20 October 2025

Re: Draft Environmental Impact Statement, Mission Ridge Expansion Master Planned Resort

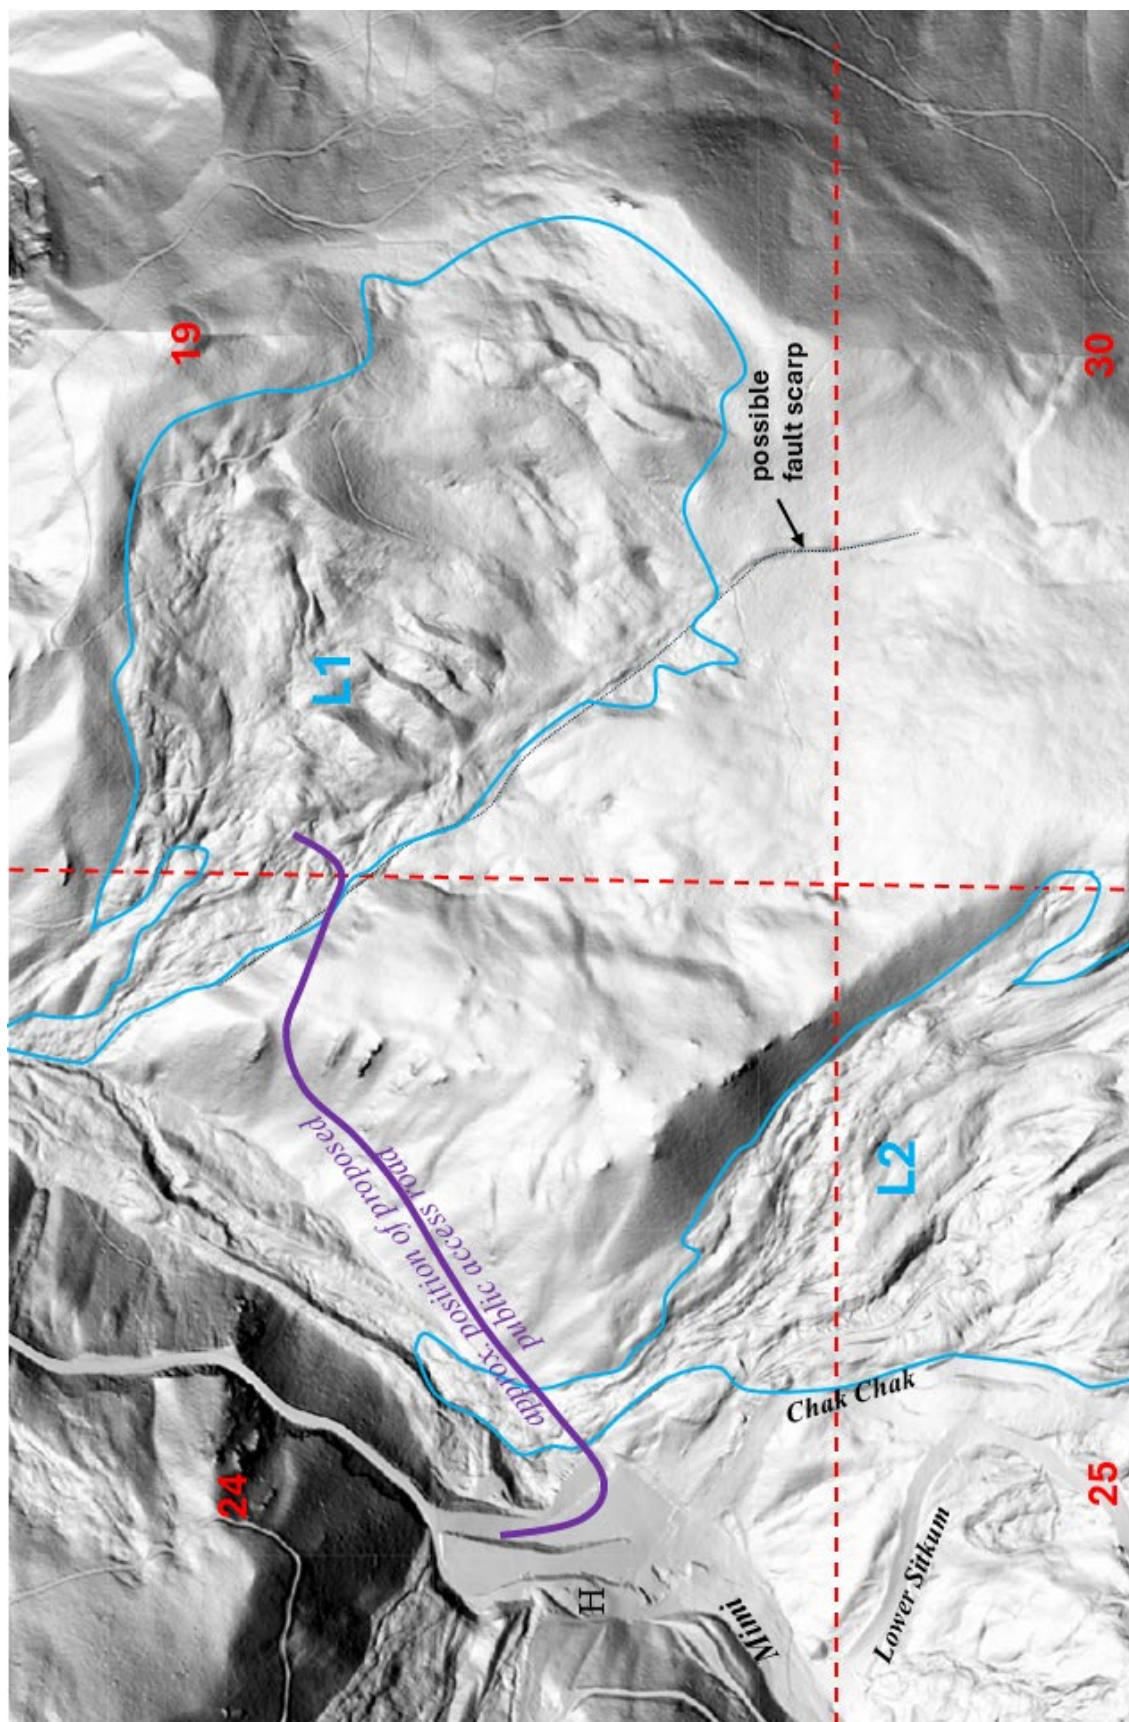
When I look at lidar topography ([Washington Lidar Portal](#)) (Fig. 1) of the area of the proposed Mission Ridge expansion, I see two significant landslides. The first landslide (L1) occupies much of the W½ of Section 19, T21N R20E and extends downhill into the eastern edge of Section 24, T21N R19E. Most of the development (commercial buildings, residences, maintenance facilities, residential access roads, utility distribution lines) proposed as part of the Mission Ridge expansion is in this landslide. Tabor and others (1982) fairly accurately mapped this landslide as unit Qls (Landslide deposits, undifferentiated). The morphology of this landslide is complex: large rotational blocks in its upper region transition downslope into debris flows that reached Squilchuck Creek. The SW margin of the landslide may be located along a recent fault (Fig. 1).

The second landslide (L2), partly mapped in Fig. 1, is mostly in the NE¼ of Section 25, T21N R19E, east of Chak Chak ski run, and extends downhill to the NW into the SW¼ of the SE¼ of Section 24. The proposed public access road to the development crosses this landslide. Tabor and others (1982) mapped most of this landslide as unit Qrg (Rock glacier deposits—Angular locally derived boulders forming bulbous tongue) and mapped the lowermost part as Qa (Alluvium).

Previous mapping (Tabor and others, 1982) and my field observations (Fig. 2) suggest much of the proposed public access road route (Fig. 1) is underlain by Eocene fanglomerate and sandstone. Lidar topography shows ribs on the slope above that I interpret as outcrops of resistant beds of sedimentary rock. Orientations of the ribs are consistent with the NNW strike and steep NE dip of bedding I measured in outcrop along the pioneer road. Seismic surveys and exploratory borings by GNN confirm that these are reasonably competent rocks. However, unlike granitic intrusive rocks (which is what GNN identified them as), fanglomerate and sandstone are likely to be interbedded with layers of less competent mudstone and siltstone.
